PROJECT NAME: RANDOLPH  
PROJECT NUMBER: CMG PARK(2)IS

FILE NAME: ... \Plot+files\02\_zk000frm\_por.plot DATE: 8/3/2007  
PROJECT LEADER: WLD DRAWN BY: STANTEC  
DESIGNED BY: STANTEC CHECKED BY: GAS  
TYPICAL SECTIONS SHEET 1 SHEET 2 OF 63

PROJECT NAME: RANDOLPH  
 PROJECT NUMBER: CMG PARK(2)IS  
 FILE NAME: ...\\Plotfiles\N4\_G&D.pjf PLOT DATE: 8/3/2007  
 PROJECT LEADER: WLD DRAWN BY: STANTEC  
 DESIGNED BY: STANTEC CHECKED BY: GAS  
**GRADING AND DRAINAGE PLAN** SHEET 20 OF 63

PROJECT NAME: RANDOLPH  
 PROJECT NUMBER: CMG PARK(2)S  
 FILE NAME: ... \Plotfiles\10\_Layout.ptf  
 PROJECT LEADER: WLD  
 DESIGNED BY: STANTEC  
 LAYOUT PLAN  
 PLOT DATE: 8/3/2007  
 DRAWN BY: STANTEC  
 CHECKED BY: GAS  
 SHEET 16 OF 63

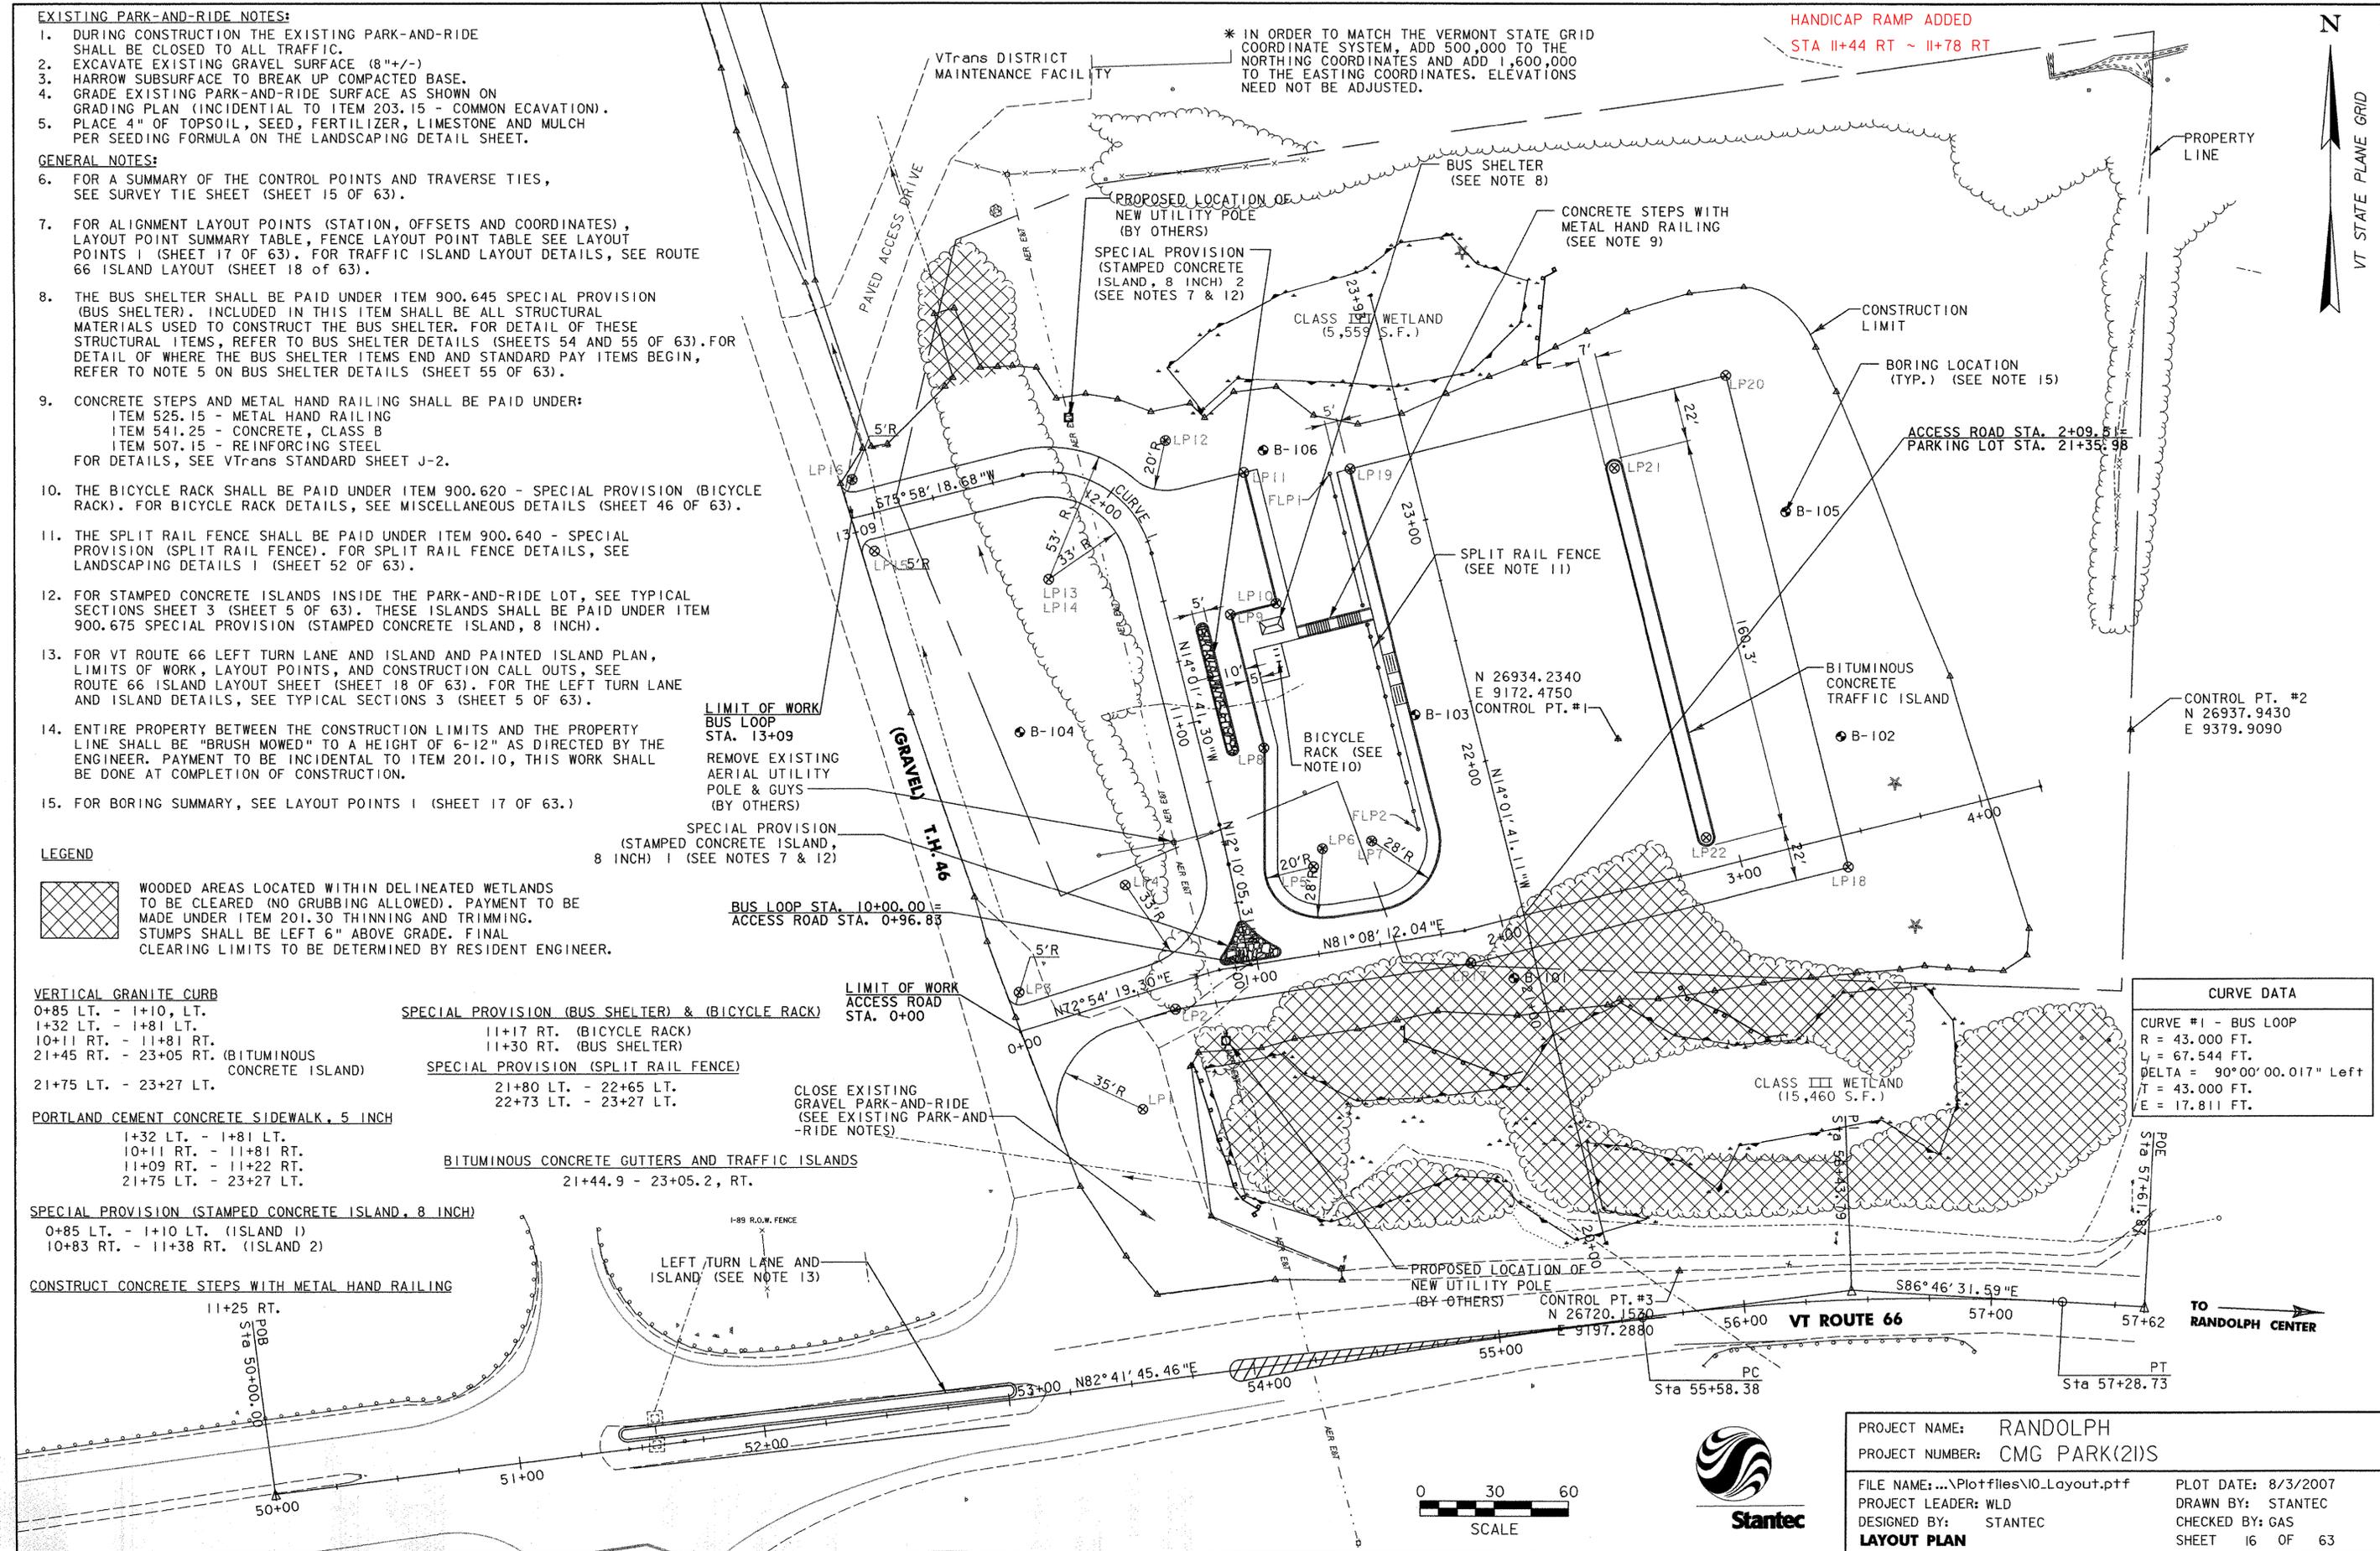
HANDICAP RAMP ADDED  
 STA II+44 RT ~ II+78 RT

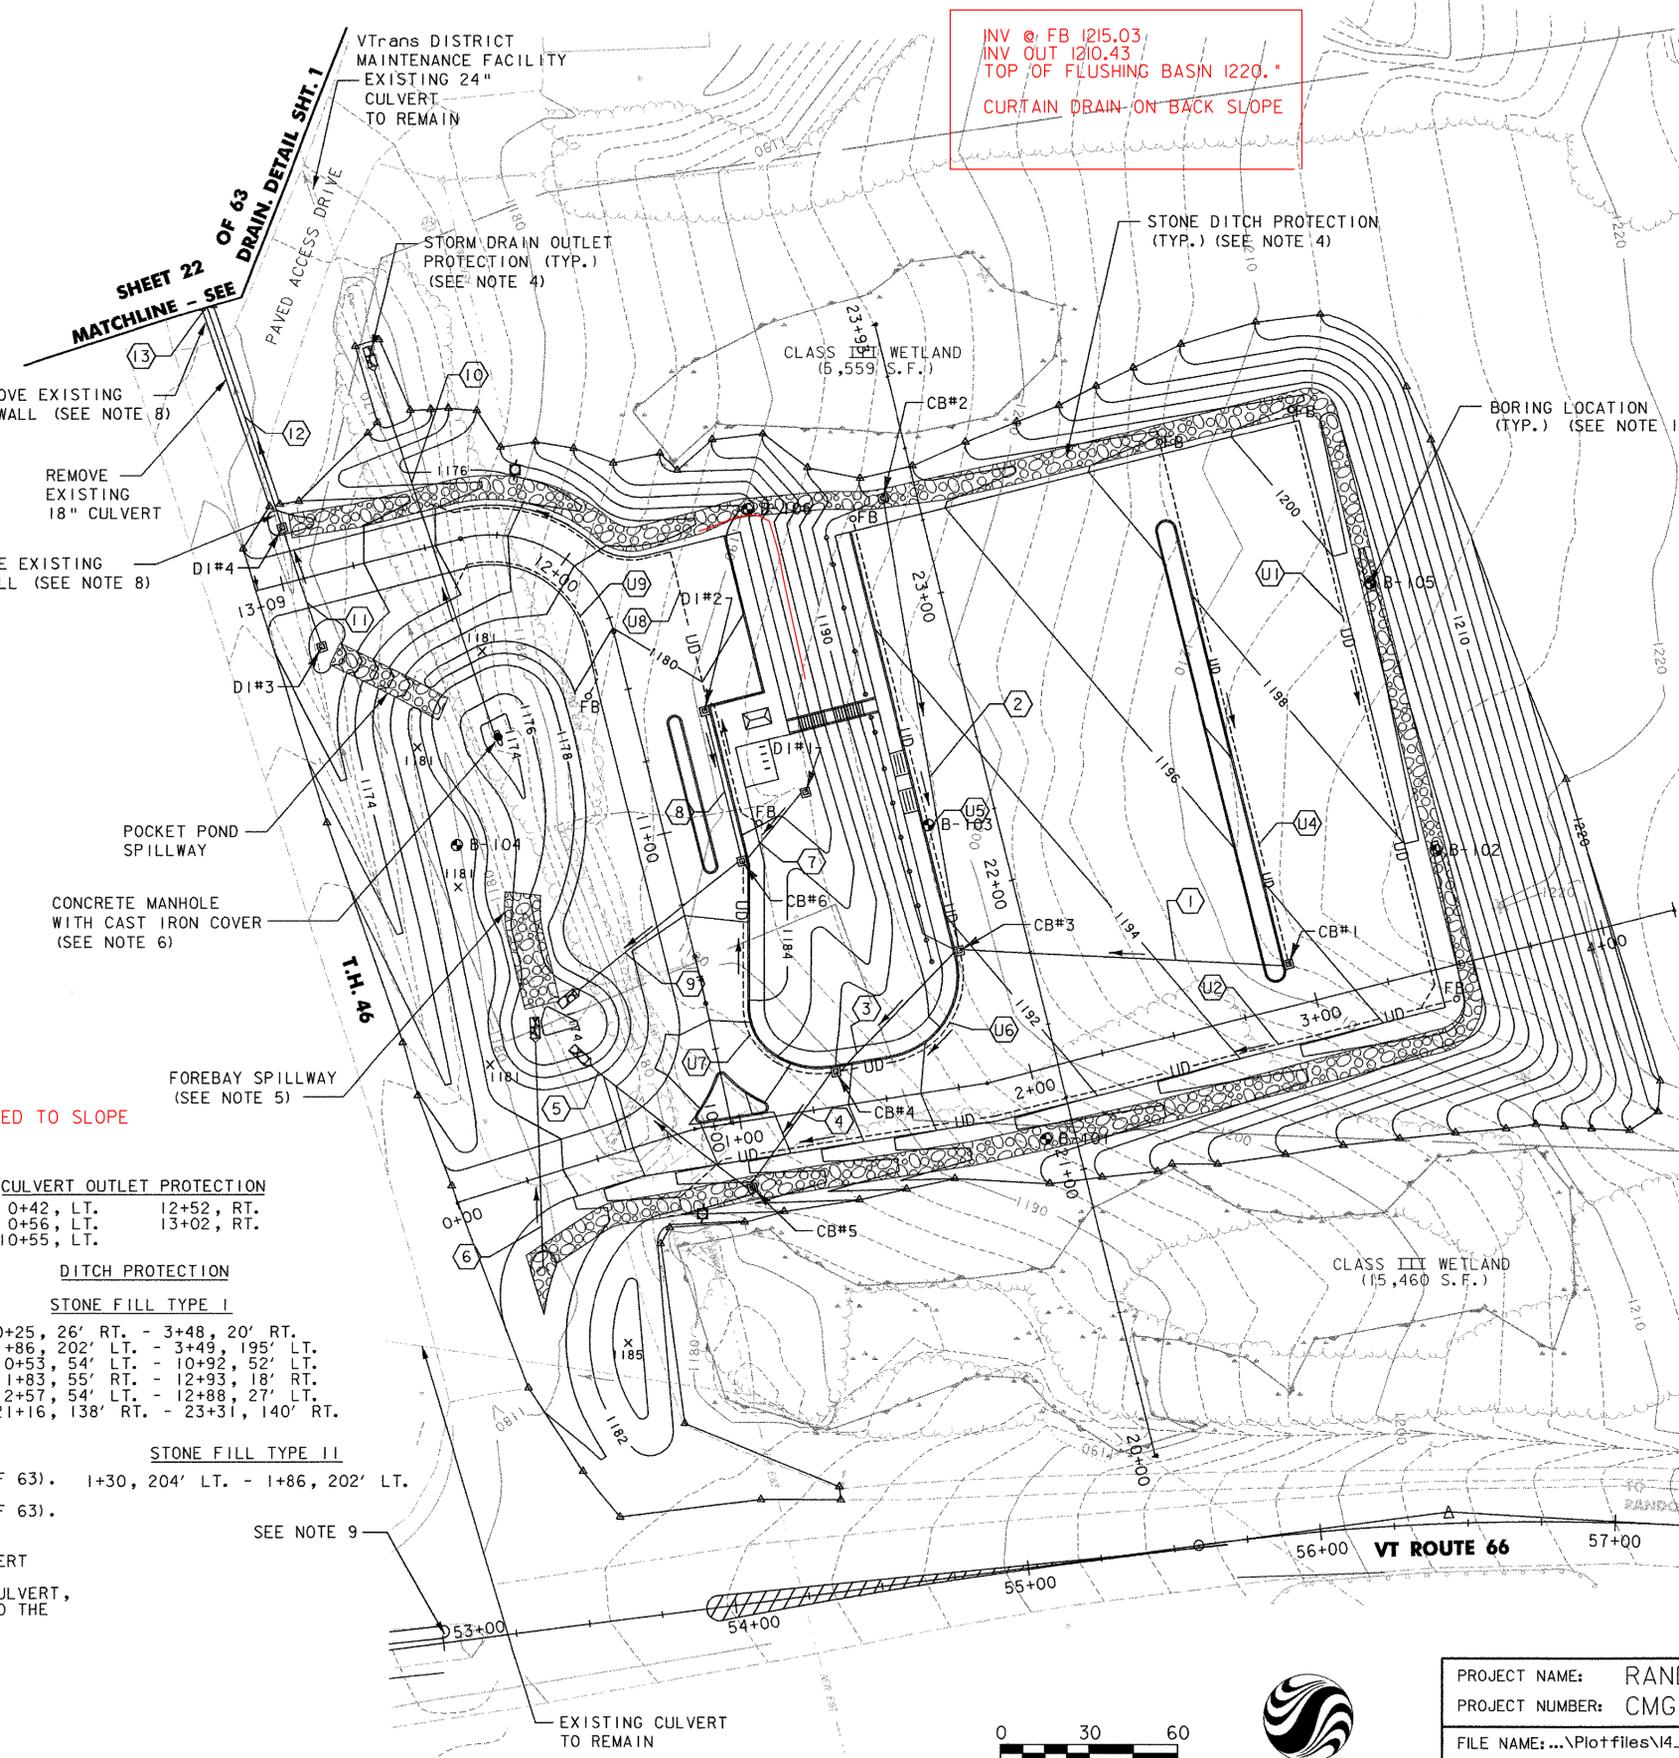
- ~~U8~~ BUS LOOP STA. 11+51, LT. TO 12+46, LT. **DELETED**  
NEW 6" X 82' UNDERDRAIN, INV. IN 1174.50, INV. OUT 1173.94  
NEW UNDERDRAIN FLUSHING BASIN AT INLET **MOVED TO SLOPE**

FILE NAME: ...\\Plotfiles\15\_zk000drn.por.plt PLOT DATE: 8/3/2007  
PROJECT LEADER: WLD DRAWN BY: STANTEC  
DESIGNED BY: STANTEC CHECKED BY: GAS  
**DRAINAGE PLAN** SHEET 21 OF 63

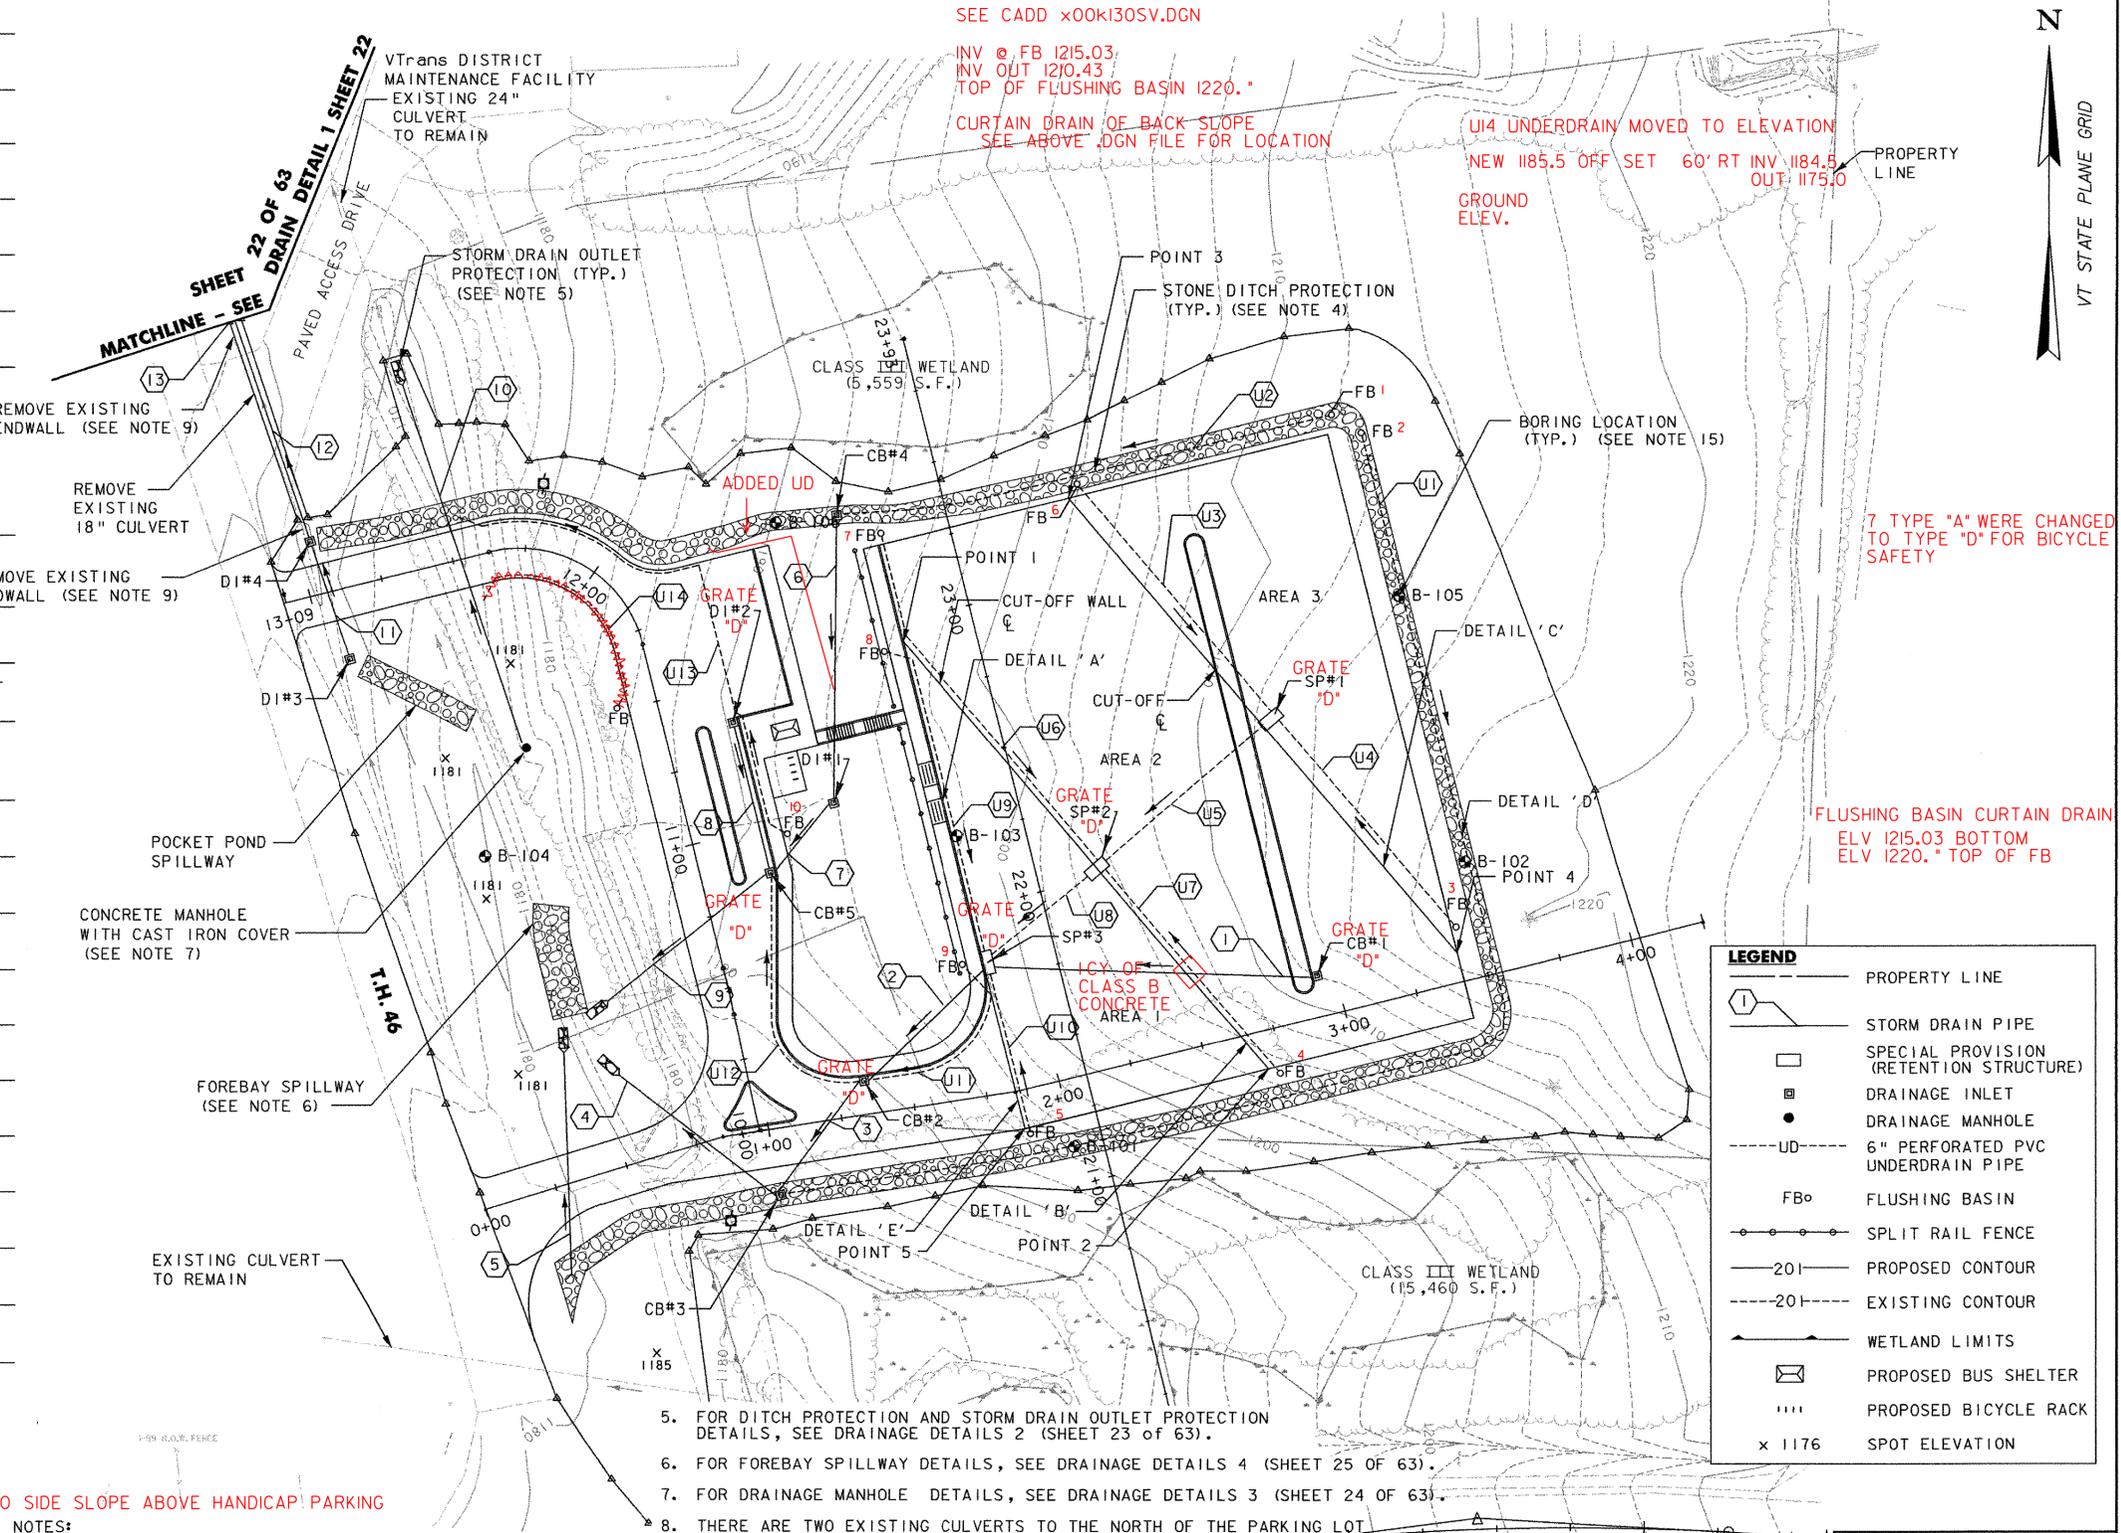
U14 UNDERDRAIN MOVED TO ELEVATION  
NEW 1185.5 OFF SET 60' RT INV 1184.5  
OUT 1175.0

7 TYPE "A" WERE CHANGED TO TYPE "D" FOR BICYCLE SAFETY
